SUBJECT: AMENDMENT NO. 112 TO PROVISIONAL OPERATING LICENSE NO. DPR-20: STEAM GENERATOR AUGMENTED INSERVICE INSPECTION PROGRAM (TAC NO. 56365)

4.14 Augmented Inservice Inspection Program for Steam Generators

SAFETY EVALUATION BY THE OFFICE OF NUCLEAR REACTOR REGULATION
RELATED TO AMENDMENT NO. 112 TO PROVISIONAL OPERATING LICENSE NO. DPR-20
CONSUMERS POWER COMPANY
PALISADES PLANT
DOCKET NO. 50-255

FIGURE 4.14.1 - SUPPLEMENTARY SAMPLING FLOW CHART

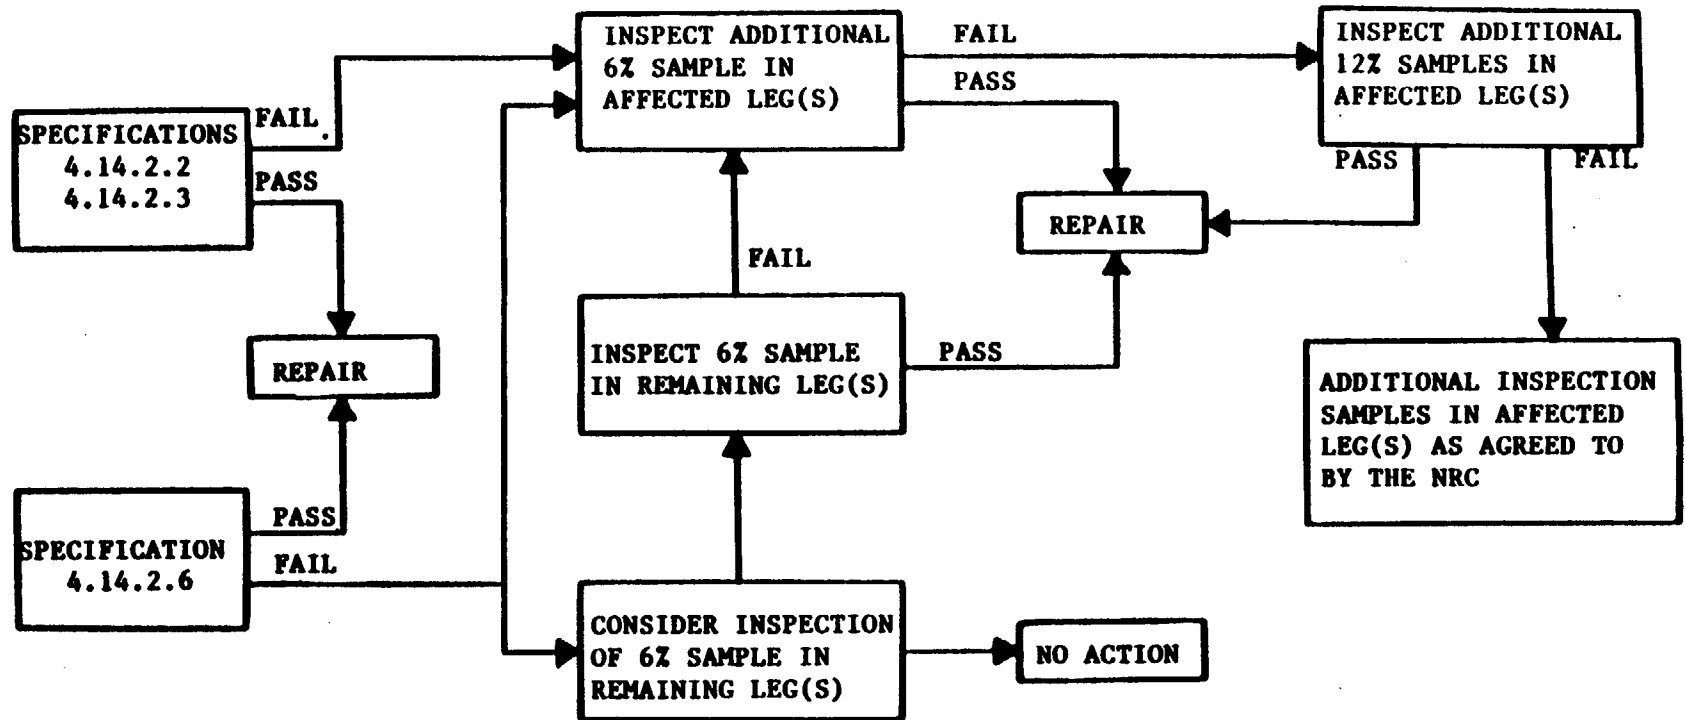
This section adds a proposed new requirement; namely should initial inspection sampling in accordance with Sections 4.14.2.2, 4.14.2.3, or 4.14.2.6 yield results exceeding one or more of the following criteria, then supplementary samples of unplugged tubes shall be inspected in accordance with Figure 4.14.1.

In the event that one or more of the above criteria are exceeded during initial inspection sampling, Figure 4.14.1 would require that an additional 6% sample of tubes be inspected. If the results of the second sample exceed the above criteria, then an additional 12% sample would have to be inspected. If the results of this third sample exceed the above criteria, then additional inspection samples must be performed as agreed to by the NRC.

The current Technical Specifications for Palisades contain no requirements for supplementary sample inspections. The supplementary sampling requirements now being proposed are still less stringent than what is specified in the Technical Specifications for virtually all other plants. The staff finds this not to pose any immediate concern since corrosion degradation has been largely arrested since the 1970s. Given the current status of corrosion degradation in the Palisades steam generators the staff believes the Technical Specification

The above comments notwithstanding, the proposed supplementary sampling requirements in Section 4.14.3.1 represent an upgrade of existing requirements and are therefore acceptable to the staff.

- 4.14.3 Supplementary Sampling Requirements /
- 4.14.3.1 If the inspection pursuant to 4.14.2.2 and 4.14.2.3 or 4.14.2.6 yields results that exceed one or more of the following criteria, then additional samples of unplugged tubes shall be inspected according to Figure 4.14.1. /

4.14.3.4 When applying the criteria of Specification 4.14.3.1 to the tube sample inspection results, the samples are not to be treated cumulatively. The criteria shall be applied only to the inspection results from the immediate additional sample when deciding whether or not to inspect the next additional sample in the progression of Figure 4.14.1.
